UNITED STATES PATENT AND TRADEMARK OFFICE

APPLICATION NO.	FILING DATE	FIRST NAMED INVENTOR	ATTORNEY DOCKET NO.	CONFIRMATION NO.
10/804,609	03/18/2004	Mark H. Eskridge	H0005288	9561
128	7590	06/15/2006	EXAMINER	
HONEYWELL INTERNATIONAL INC. 101 COLUMBIA ROAD P O BOX 2245 MORRISTOWN, NJ 07962-2245			NGUYEN, DILINH P	
			ART UNIT	PAPER NUMBER
			2814

Office Action Summary

DETAILED ACTION

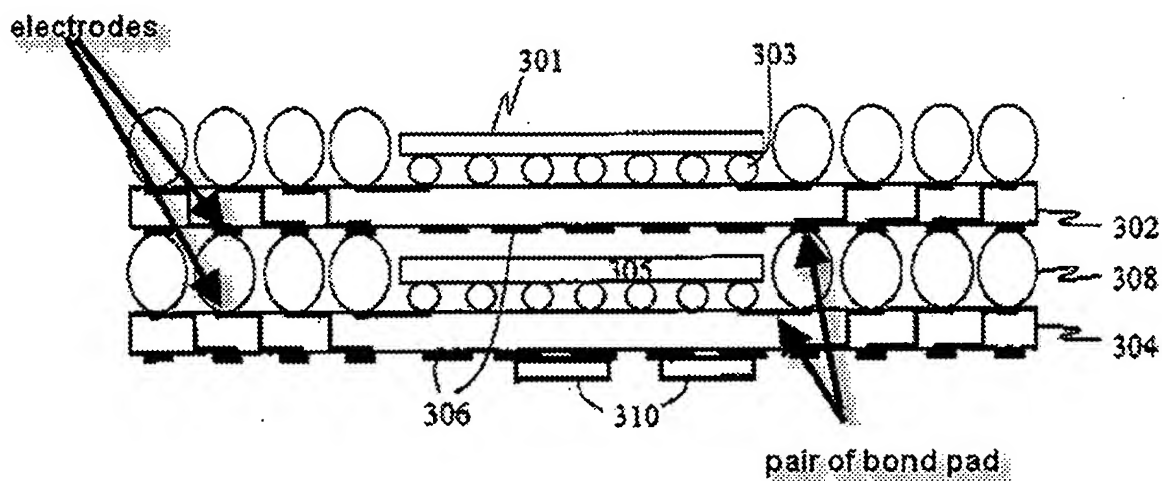
However, Ellsberry et al. disclose a semiconductor device comprising:

electrodes formed on each of the first and second mutually opposing inner substrate surfaces;

one pairs of complementary metal chip bond pads formed on the first and second mutually opposing inner substrate surfaces;

an electrical conductive path formed between one of the electrodes and one of the chip bond pads on a corresponding one of the first and second mutually opposing inner substrate surfaces; and

a gold stud bump 308 (paragraph 0021) mechanically and electrically coupled between the chip bond pads on the top and bottom substrates (cover fig). Therefore, it would have been obvious to one having ordinary skill in the art at the time the invention was made to modify the device structure of AAPA by having a plurality of metal chip bond pads formed on the inner surfaces of the top, bottom substrates and a gold stud bump between the chip bond pads on the top and bottom substrates because as taught

by Ellsberry et al., in order to provide an electrical path between the top and bottom surfaces of the substrates (cover fig.).

- Regarding claim 20, Ellsberry et al. disclose that an electrical path formed on the inner surface of the top substrate 302 and being electrically coupled to the chip bond pad (cover fig.).

- Regarding claim 21, Ellsberry et al. disclose that a plurality of wire bond pads formed on one of the first and second mutually opposing inner substrate surfaces and an electrically conductive path formed between one of the chip bond pads and one of the wire bond pads (cover fig.).
